SOUTHWEST BIKEPATH CULVERT REPLACEMENT AT WAITE CIRCLE - 2019

CITY OF MADISON, WI

CITY PROJECT NO. 8466

ADDENDUM 1
8/29/19
CHANGED ENTIRE
DRAWING

DRAWING NUMBER
C-9
 SHEET NUMBER
 15 OF 25

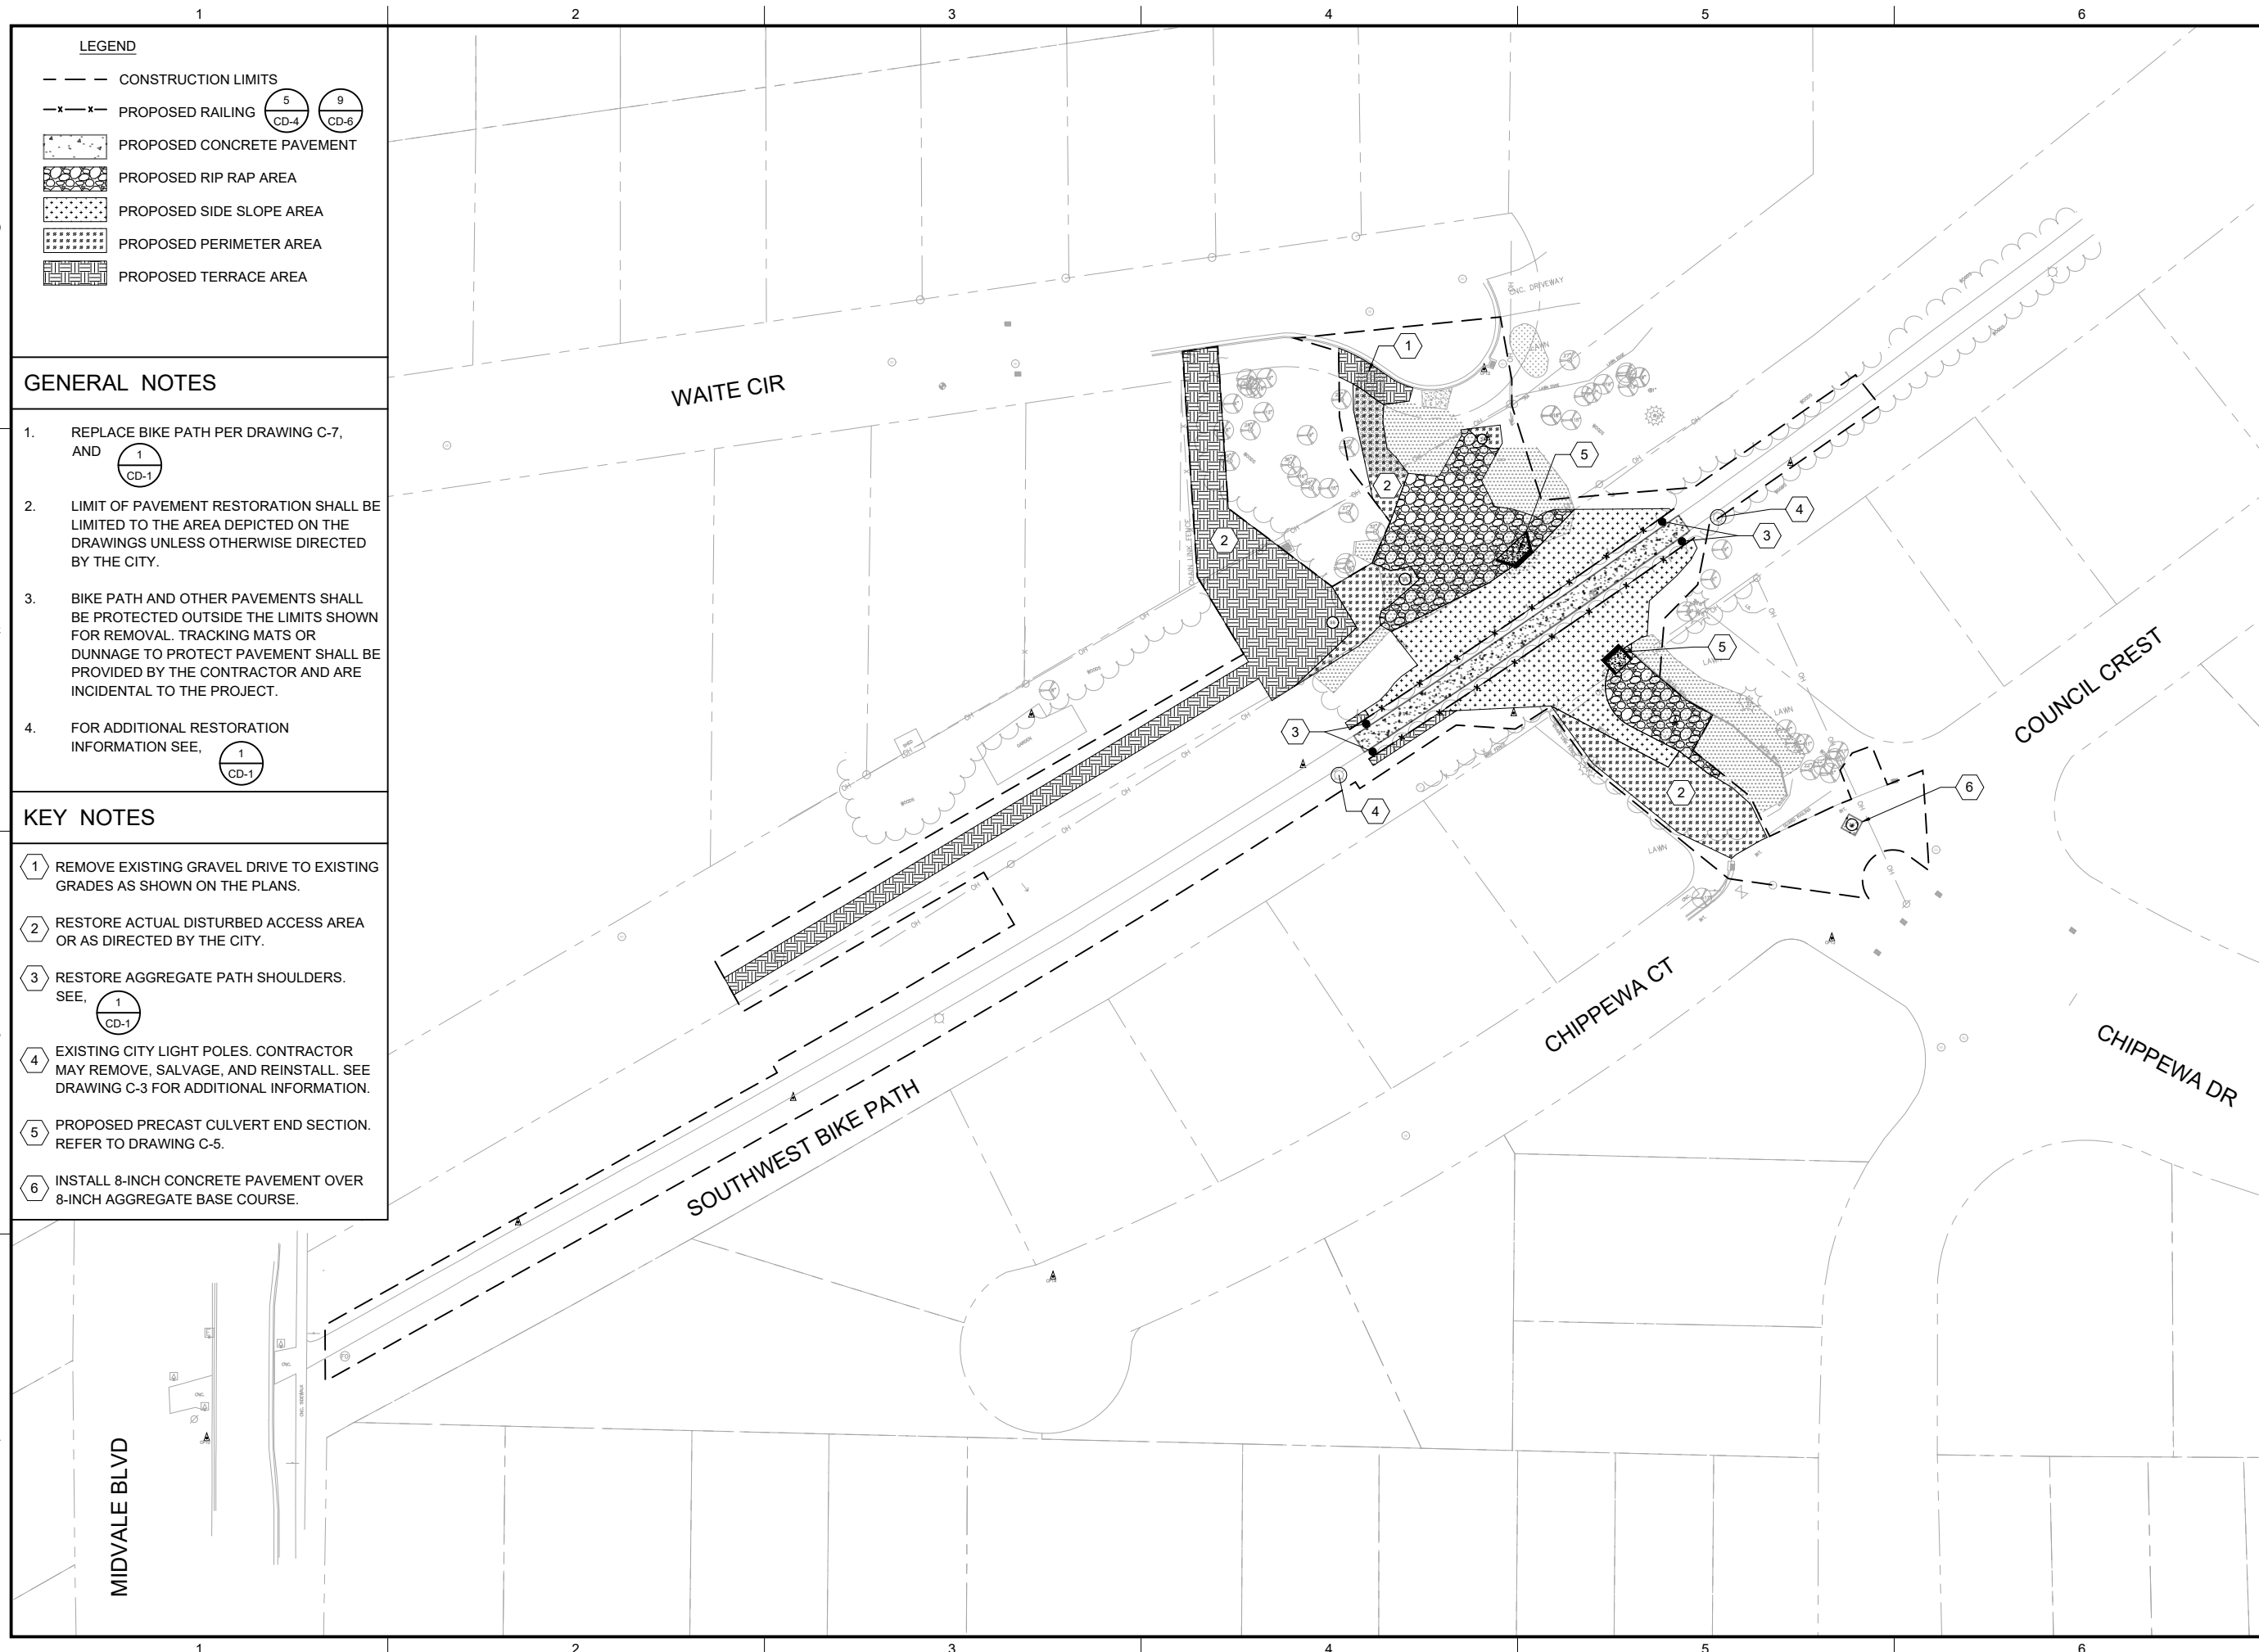
**ADDENDUM 1
CHANGED
ENTIRE
DRAWING**

DRAWING NUMBER
CD-1
 SHEET NUMBER
17 OF 25

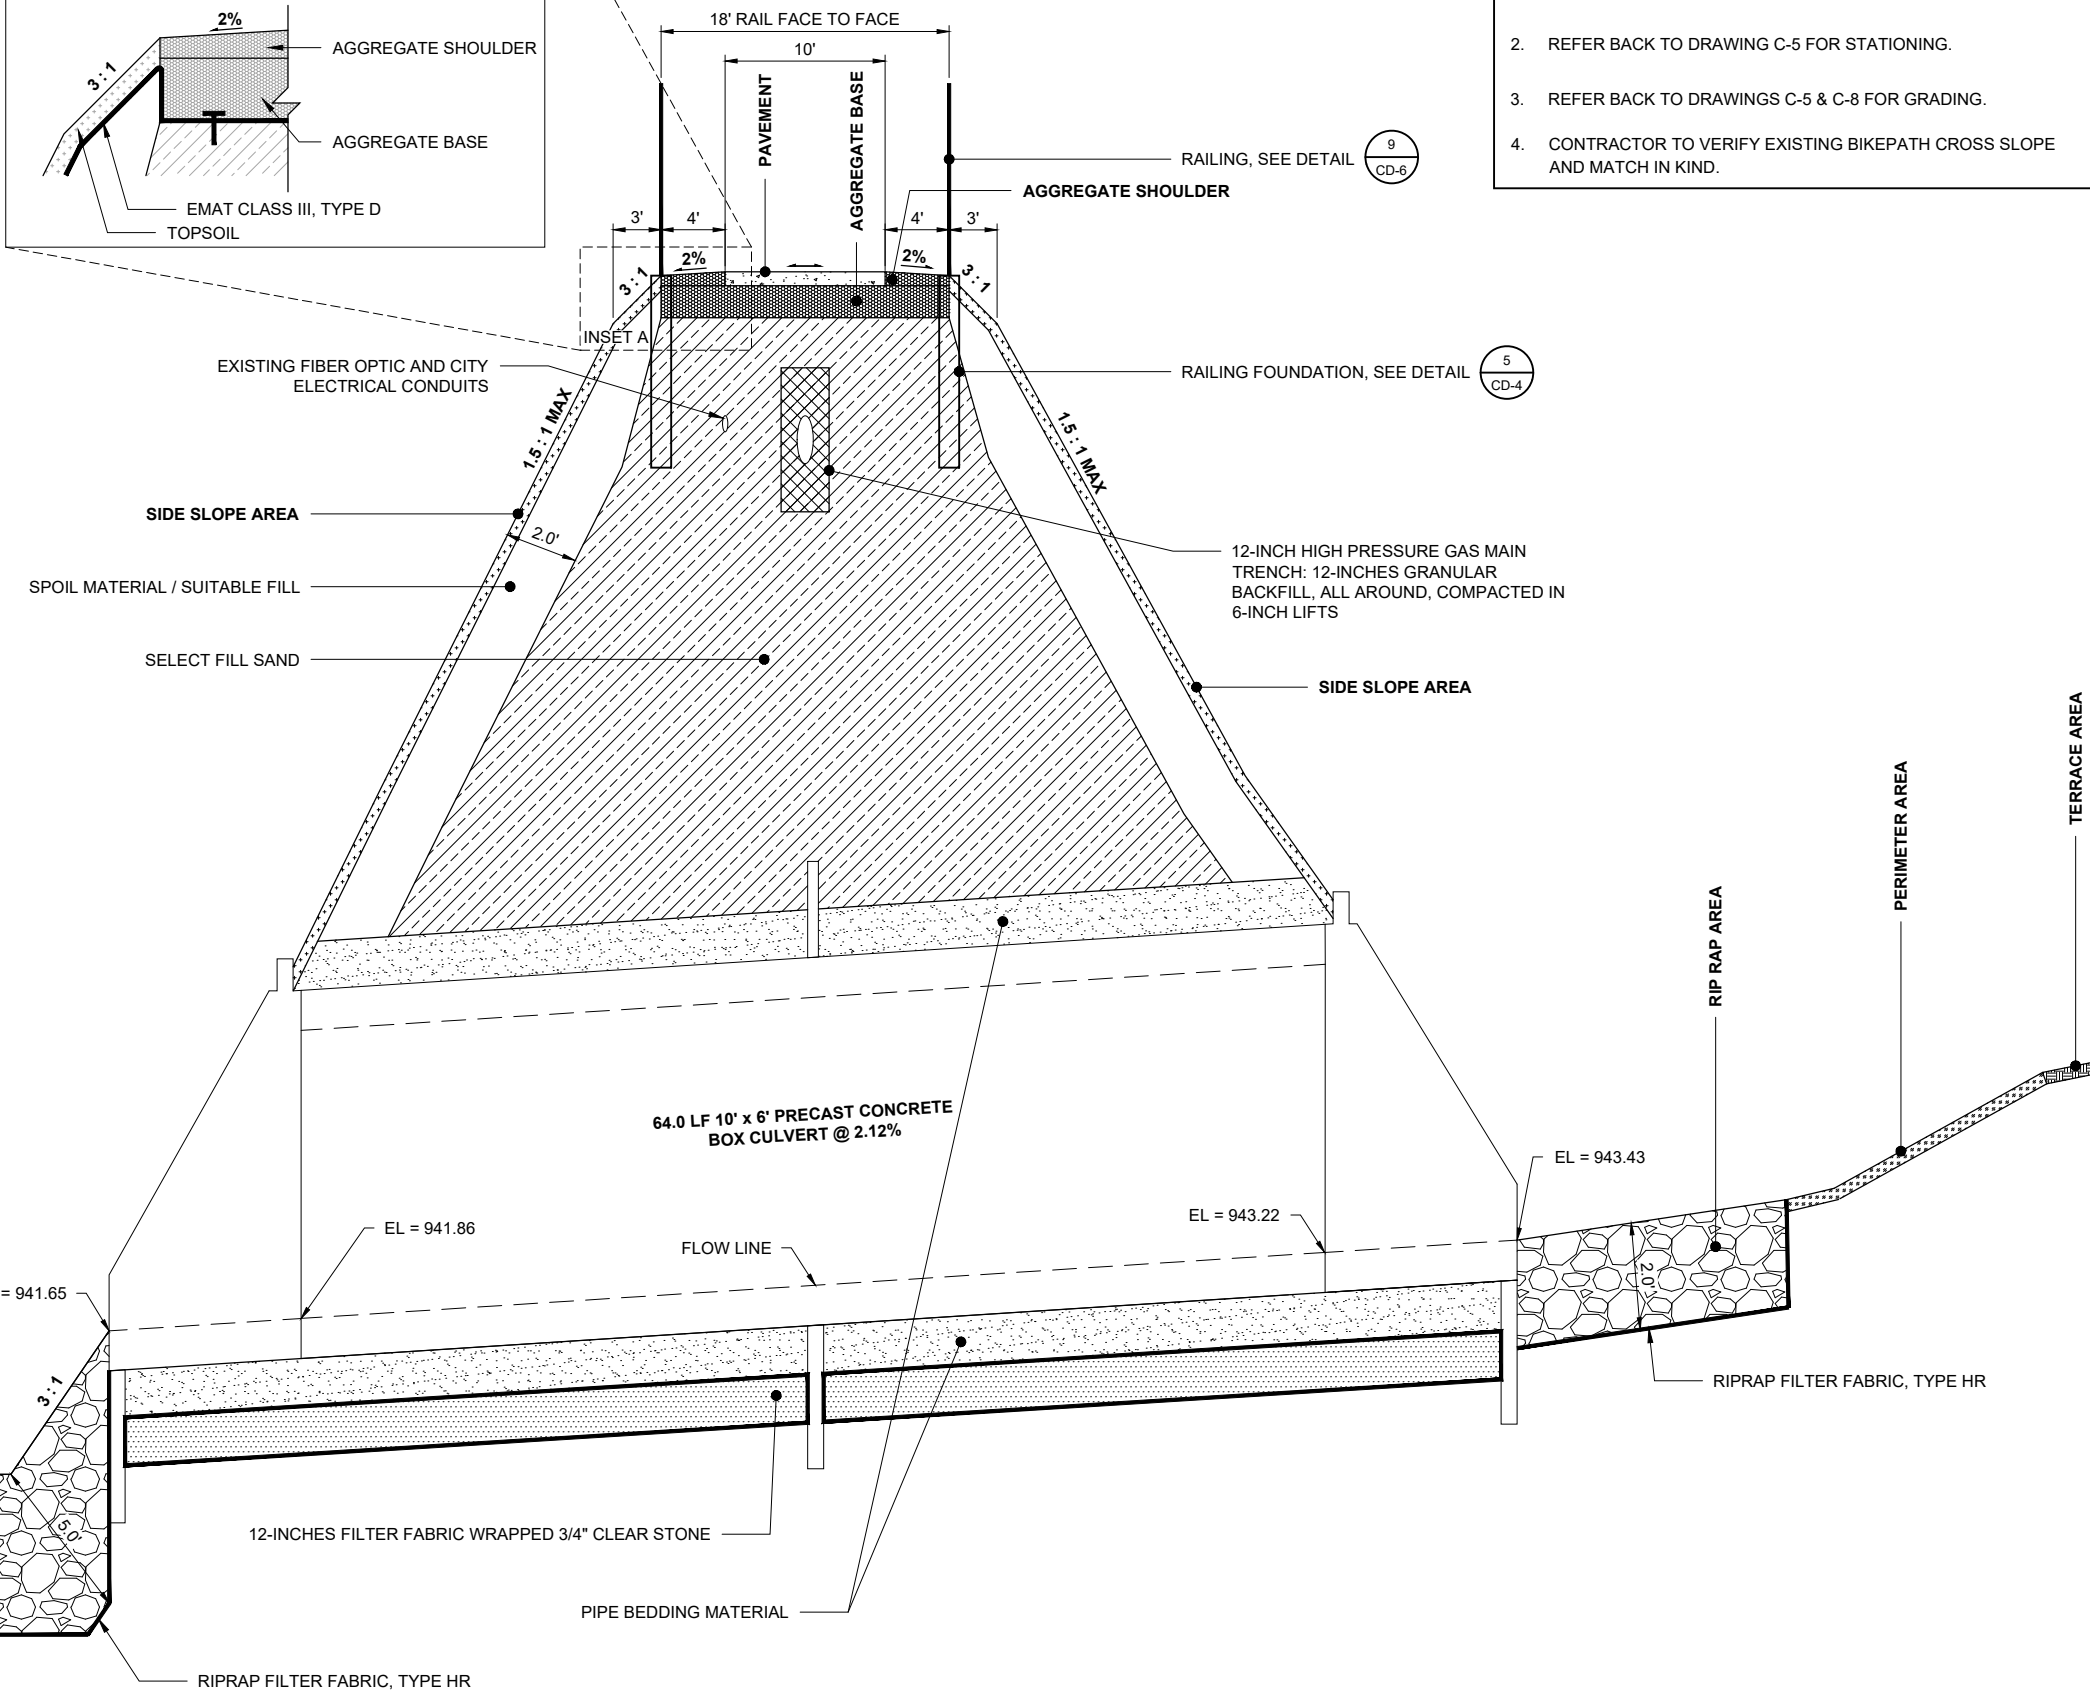
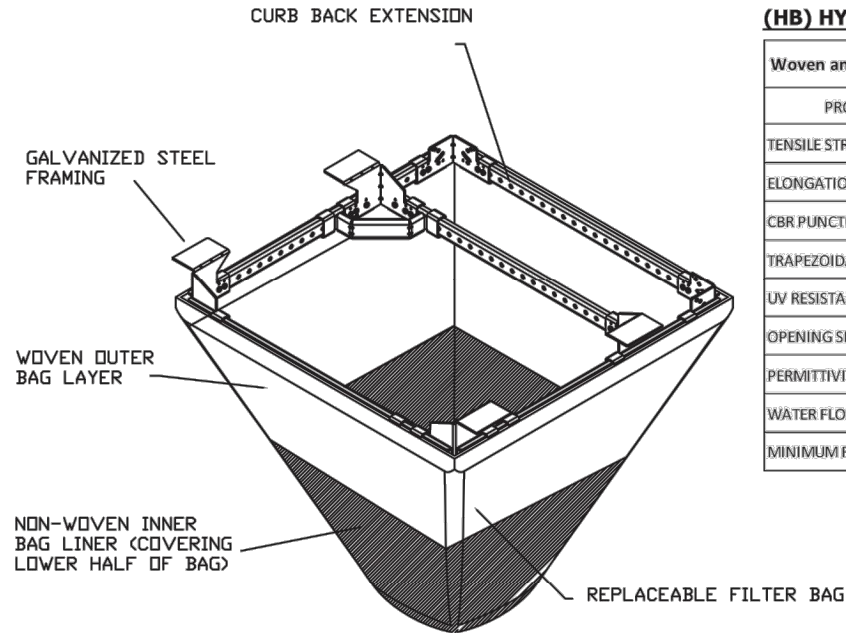
**ADDENDUM 1
CHANGED
ENTIRE
DRAWING**

DRAWING NUMBER
CD-6
 SHEET NUMBER
 22 OF 25

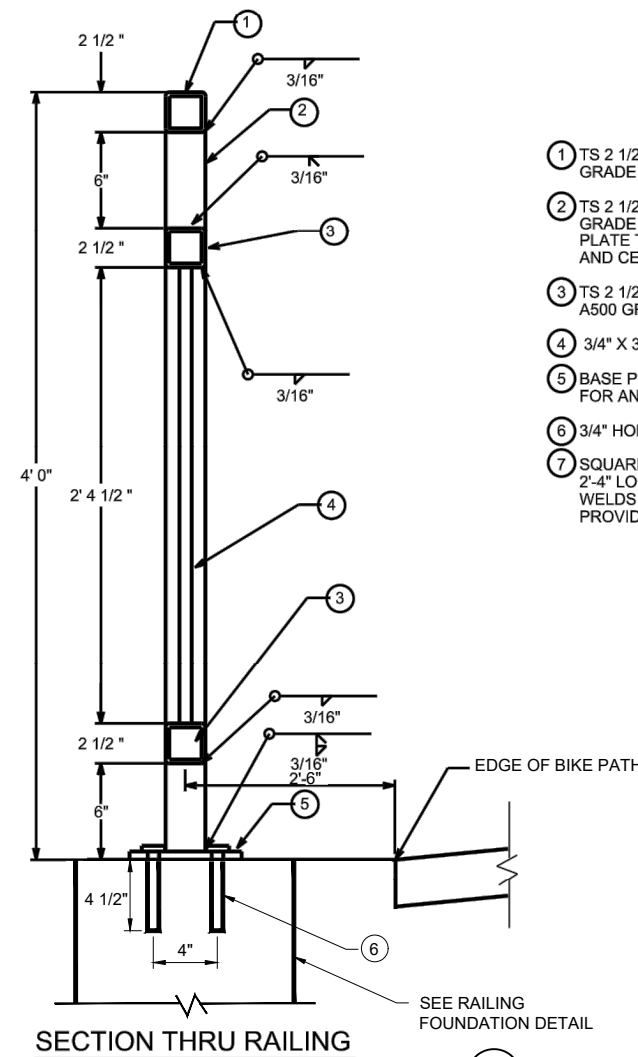
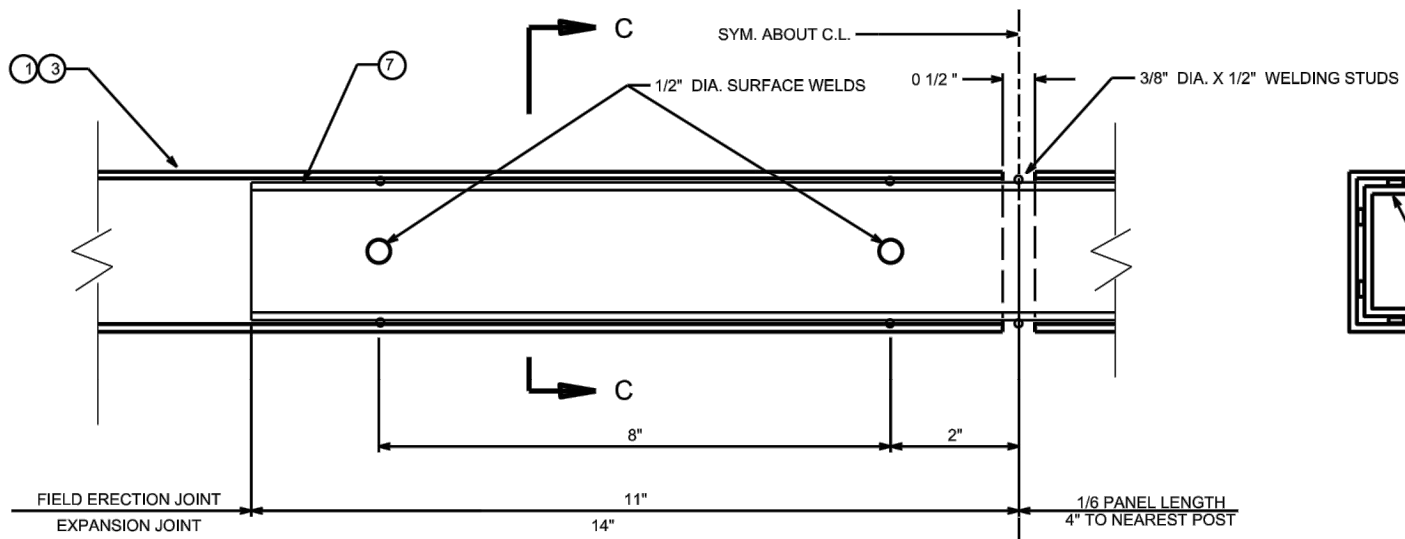
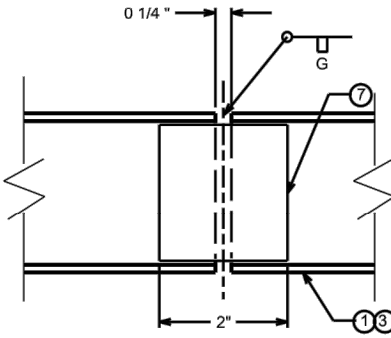
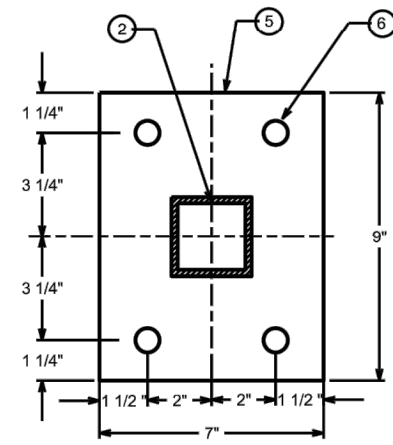
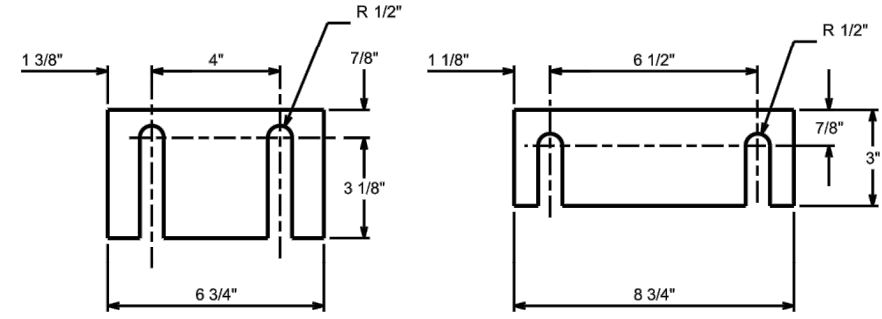
ADDENDUM 1
 CHANGED DETAIL
 NUMBER AND
 DRAWING NUMBER
